## SRFB Grant Regional Application Materials

<b>Submission Date</b>	2018-03-30 13:19:08
	Mill Creek Fish Passage Project
<b>Sponsor Organization</b>	Chelan County Natural Resource Department
<b>Sponsor Contact Person</b>	Mike Kane
<b>Sponsor Address</b>	411 Washington St
<b>City</b>	Wenatchee
<b>State</b>	WA
<b>Zip Code</b>	98801
<b>Phone Number</b>	509-885-2126
<b>E-Mail Address</b>	kanenaturalresources@gmail.com
<b>PRISM #</b>	181824
<b>Habitat Work Schedule #</b>	181824
<b>Anticipated Request- SRFB</b>	131476
<b>Anticipated Request- Tributary Committee</b>	0
<b>Total Anticipated Request (SRFB and Trib)</b>	131476
<b>Anticipated Other Funding</b>	494599
<b>Anticipated TOTAL Budget</b>	626075
<b>% of budget request from SRFB</b>	21
<b>In one or two sentences, what do you propose to do?</b>	The proposal will be for final design, permitting and construction of a fish passage barrier replacement on Mill Creek, a tributary to Peshasting Creek.
<b>What subbasin is the project in?</b>	Wenatchee

# Mill Creek Fish Passage Project

### SRFB Panel

GRADING PROFILE

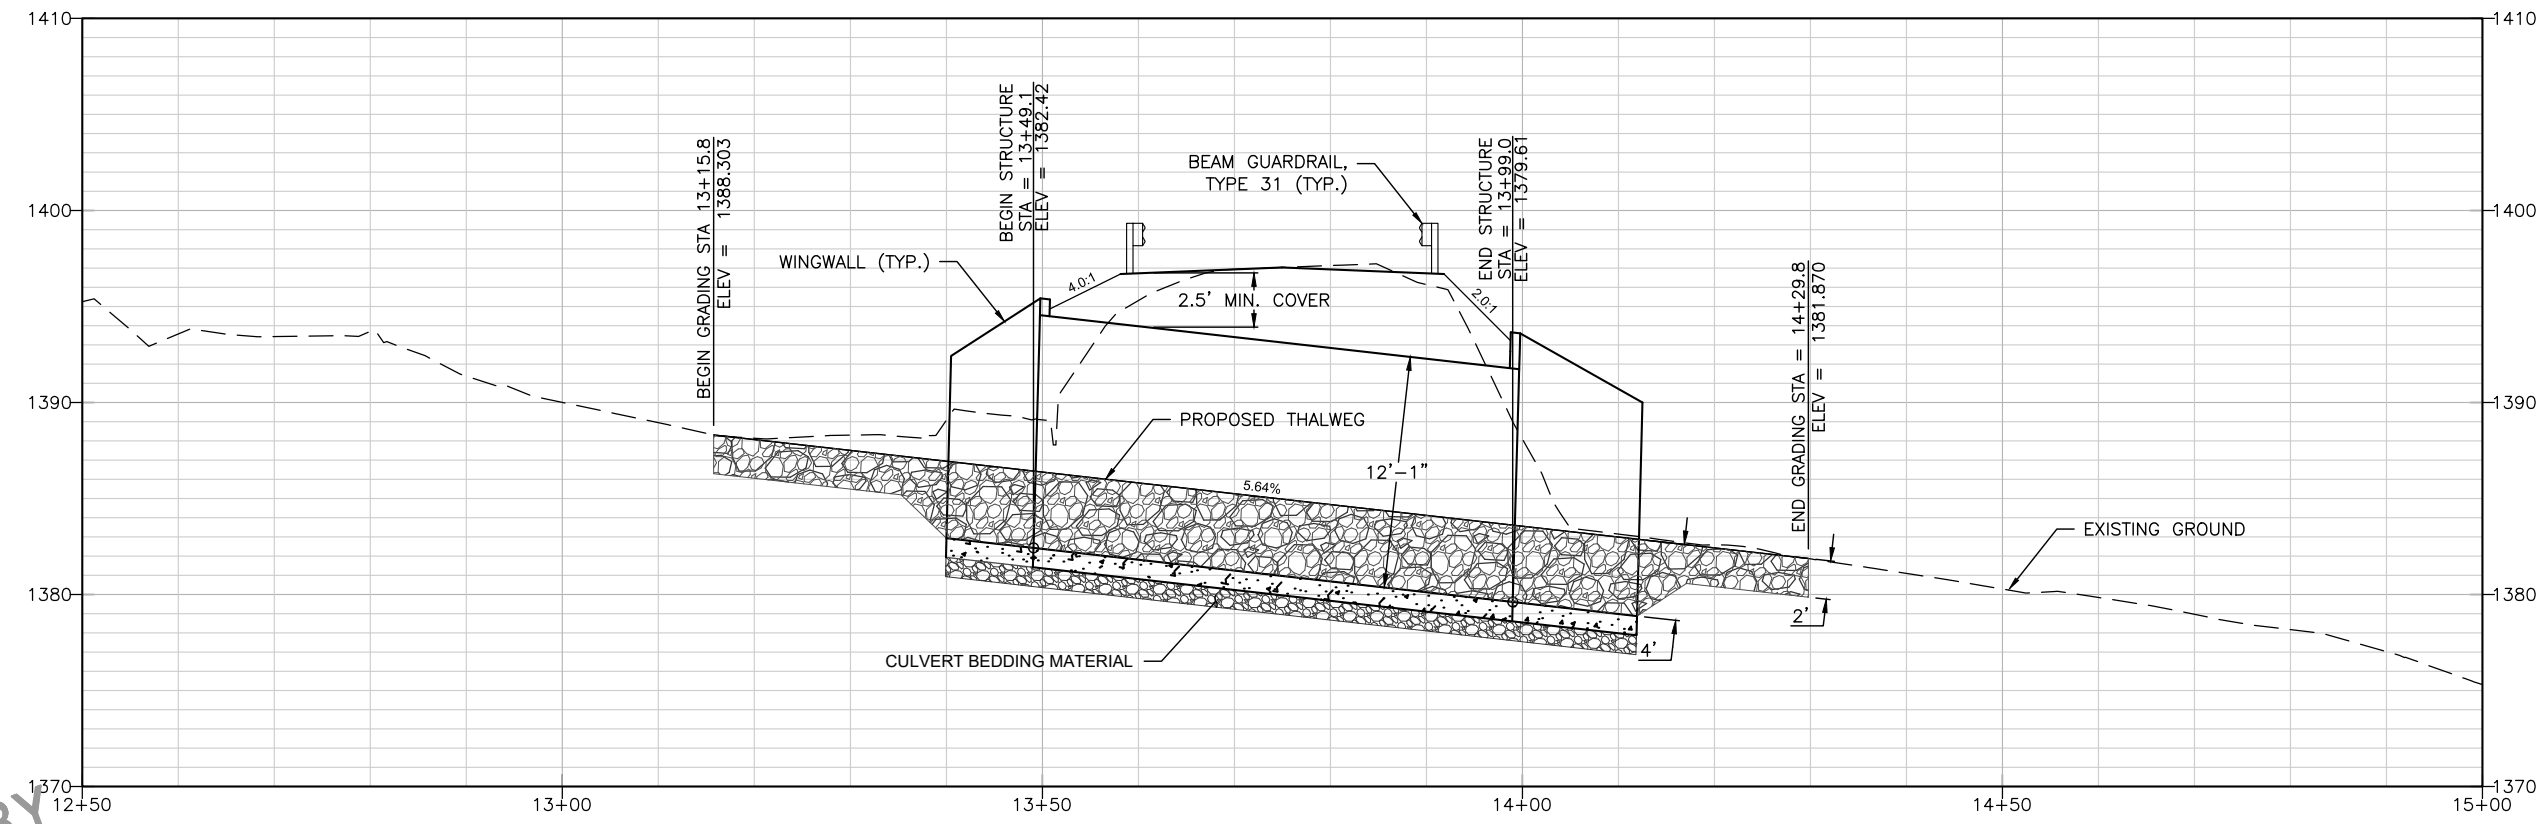
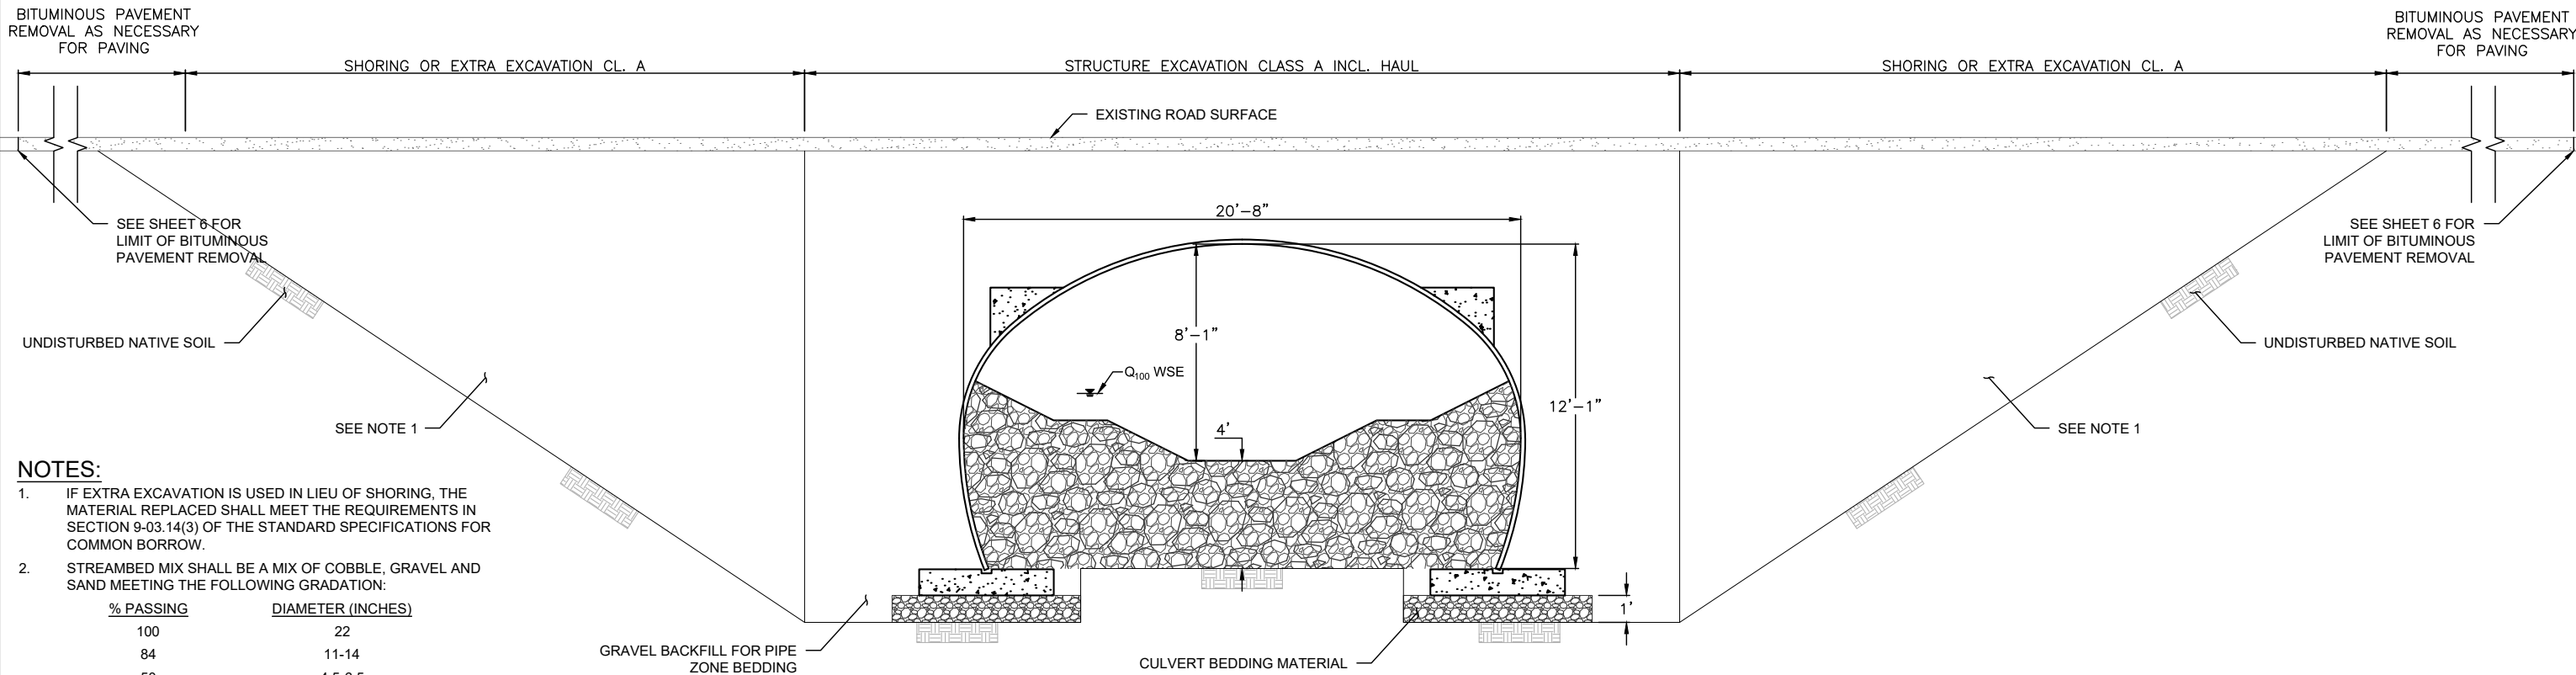
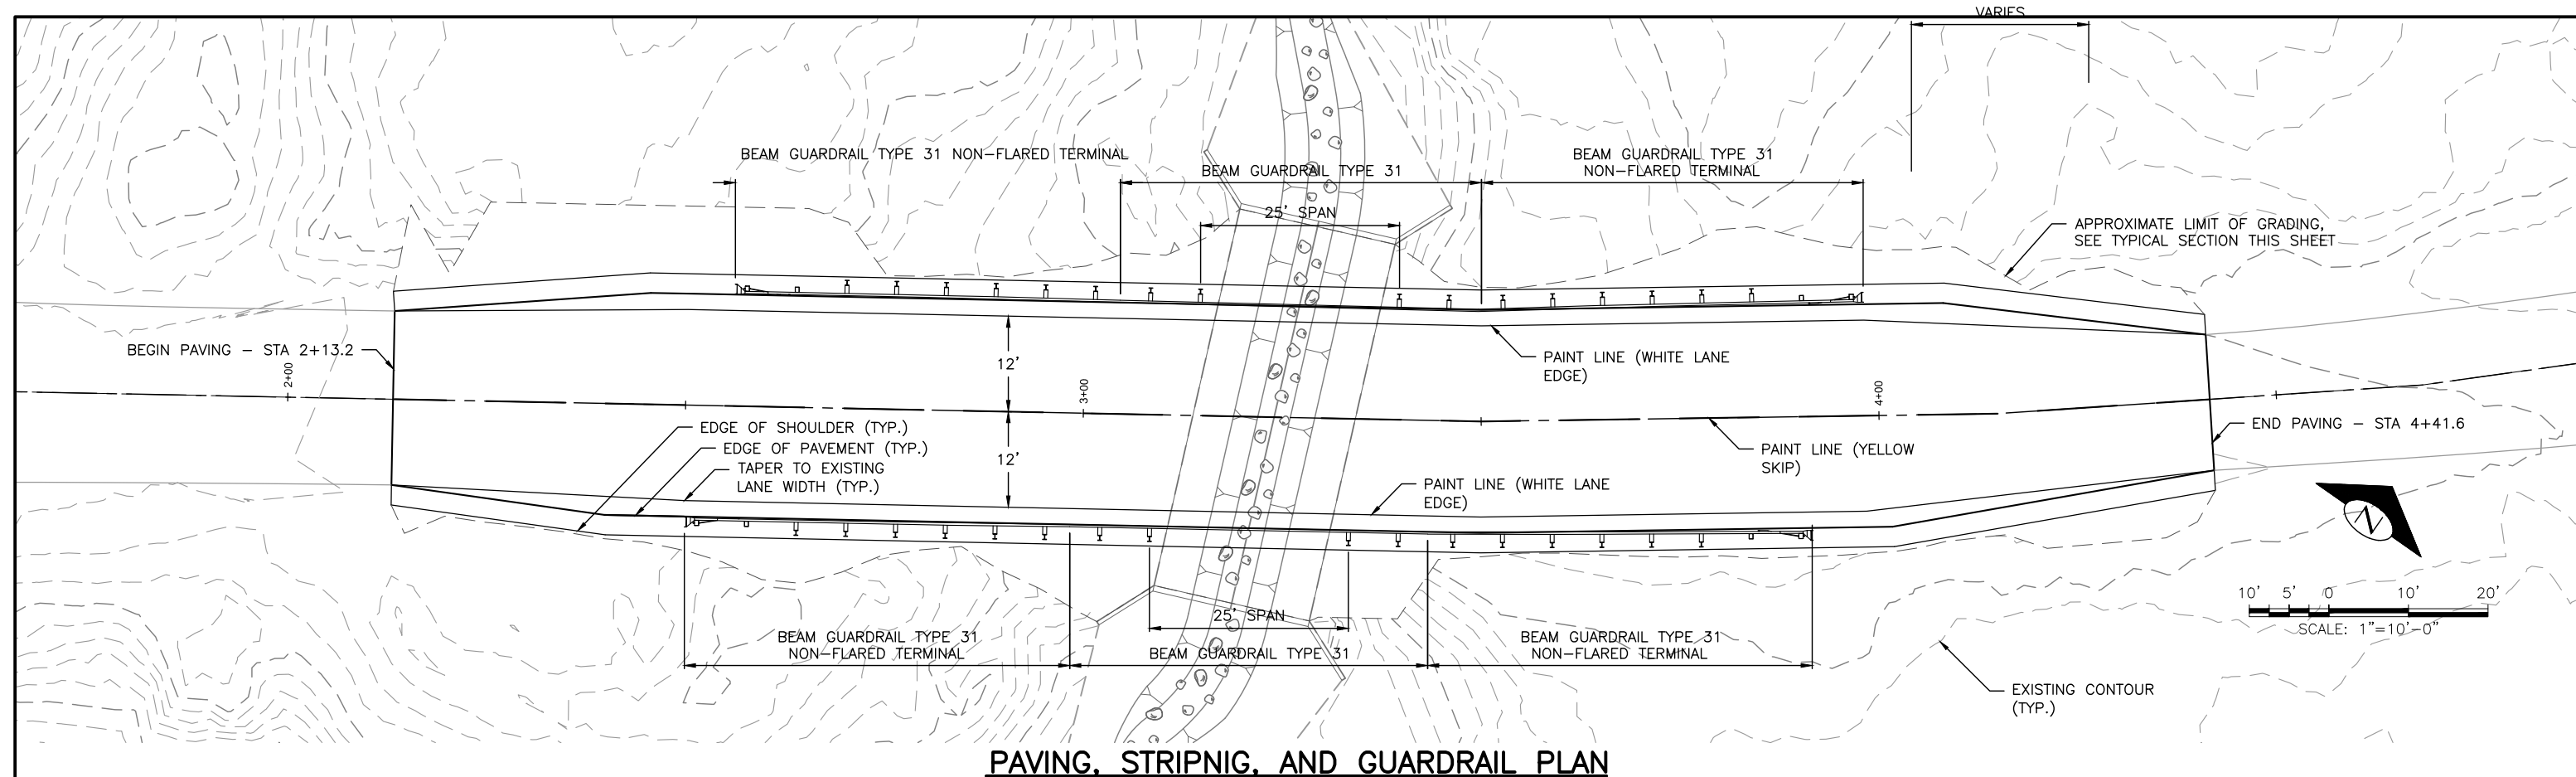
The proposal references "current 30% design"; please load this to PRISM. Preliminary designs and a basis of design (BOD) report that meet the criteria identified in Manual 18 Appendix D will need to be posted on PRISM before final application. The BOD report should include a discussion of the alternatives considered and the rationale for the preferred selection. If this will not be feasible, the grant should be for design and permits, without construction. The cost estimate shows nice detail on construction costs but should also include match and show the total project cost.

"Figure 5" of this document is the complete set of 30% design plans. 60% preliminary designs have not been completed. The design team has included total project cost and anticipated match from FBRB for this project, but does not have a completed basis of design report at this time and does not have current funding to complete prior to the final PRISM submittal. The sponsor has reduced the ask from SRFB to \$131,476 (21%).
